**Woodside Urban Park Facility Plan, Forest Conservation and Variance, PP22012003**

**Woodside Urban Park Facility Plan,  
Forest Conservation Plan and Variance, PP22012003**

Figure 2: Trees Requiring a Variance

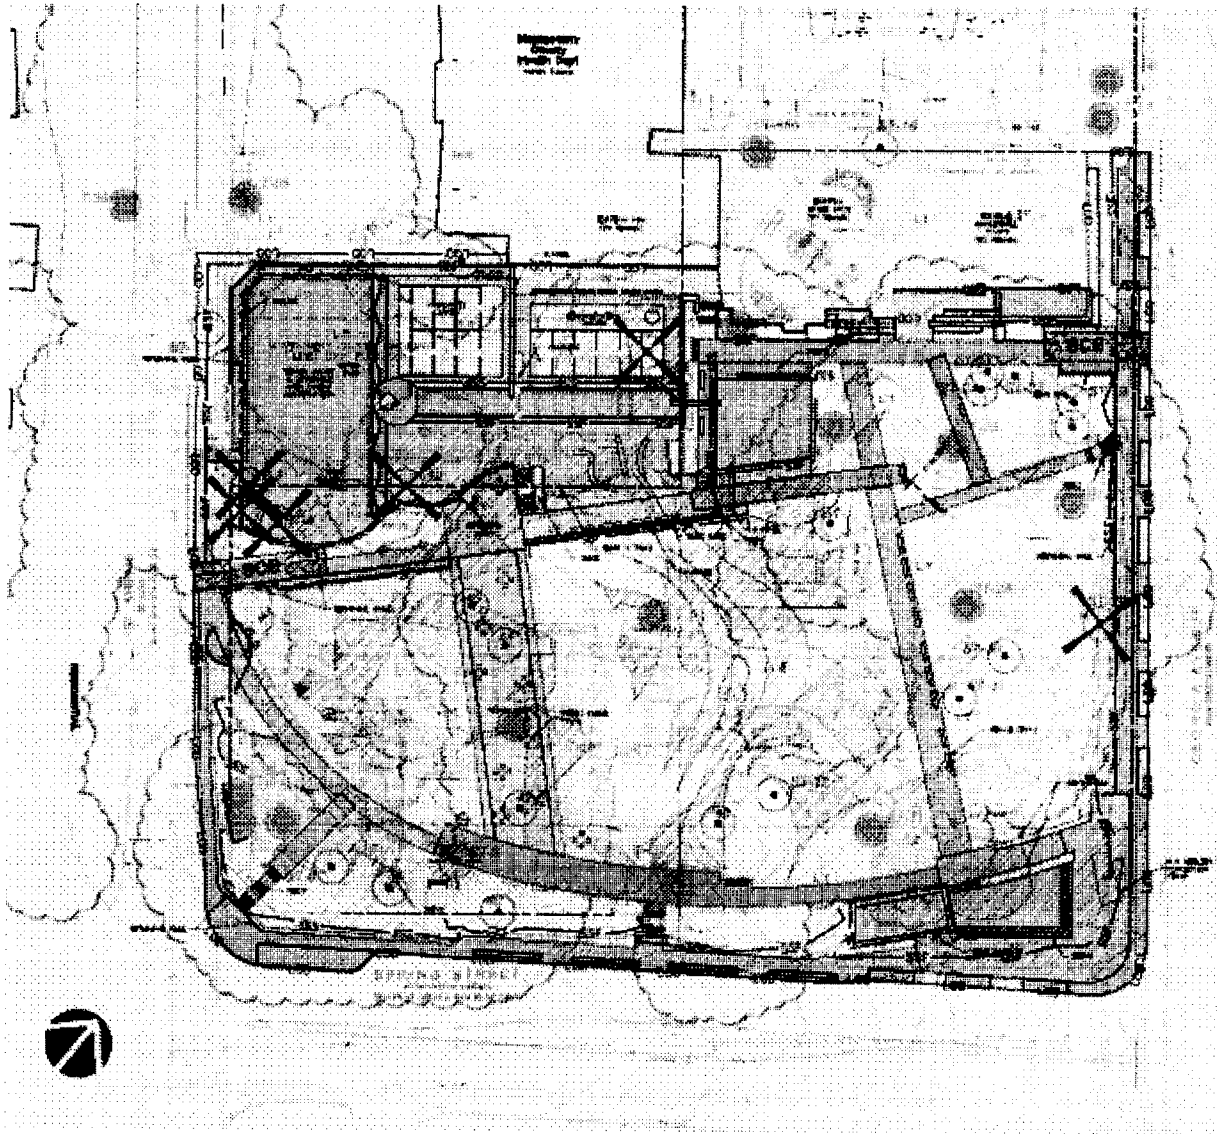
The applicant submitted a variance request on September 2, 2011 (Attachment A) for impacts to all specimen trees within the proposed limits of disturbance and one specimen tree on private property west of Woodside Park. The variance does not propose the removal of any specimen trees but there will be extensive impacts to the CRZ of all 17 specimen trees. The variance identifies grading activities including fill and cut, often both, within the CRZ of singular specimen trees. The application has not identified the amount of impact to the specimen trees and all specimen trees are within the limits of disturbance.

In an effort to protect the specimen trees the Parks Department has worked with their team of urban foresters and experienced arborists to develop strategies to maximize tree survival. A variety of tree protection approaches and best management practices will be applied to each tree based on the proposed work and design objective. Tree preservation methods include:

Preliminary Forest Conservation Plan
Woodside Urban Park
Facility Plan
WSSC Grid Map #210N2 & #211N2
SCALE: 1"=30'

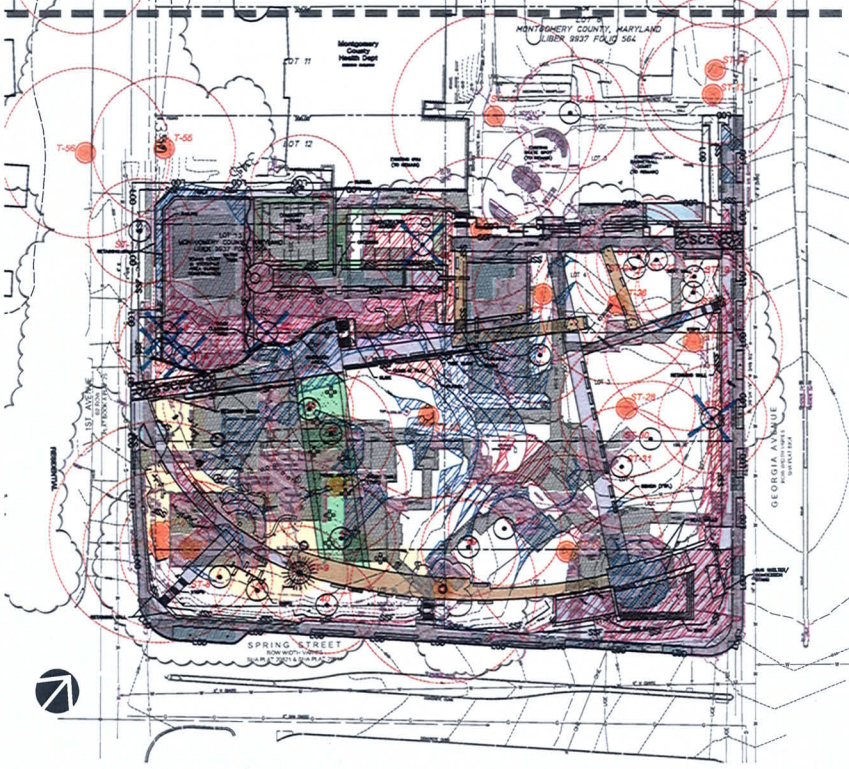
- 1) The applicant must submit a revised preliminary forest conservation plan to:
  - a. Show the exact percentage of critical root disturbance to the specimen trees

- b. Correct the land use category on the forest conservation worksheet from high density residential to institutional development area.
- 2) The applicant must submit a final forest conservation consistent with Section 109.B of the forest conservation regulations.

- a. The final forest conservation plan must provide further descriptive details for the protection of all trees.
  - b. Show the locations and dimensions of proposed stock pile areas

- c. Provide MNCPPC Standard Notes (typical sequence of events and inspection)
  - d. Provide confirmation that DPS will accept the proposed trenchless sediment control devices

- e. Show that afforestation requirements will be met (location, species, size, tree protection measures, and acreage of trees to be planted)
  - f. The final forest conservation plan must be approved prior to any land disturbing activities occurring on site.
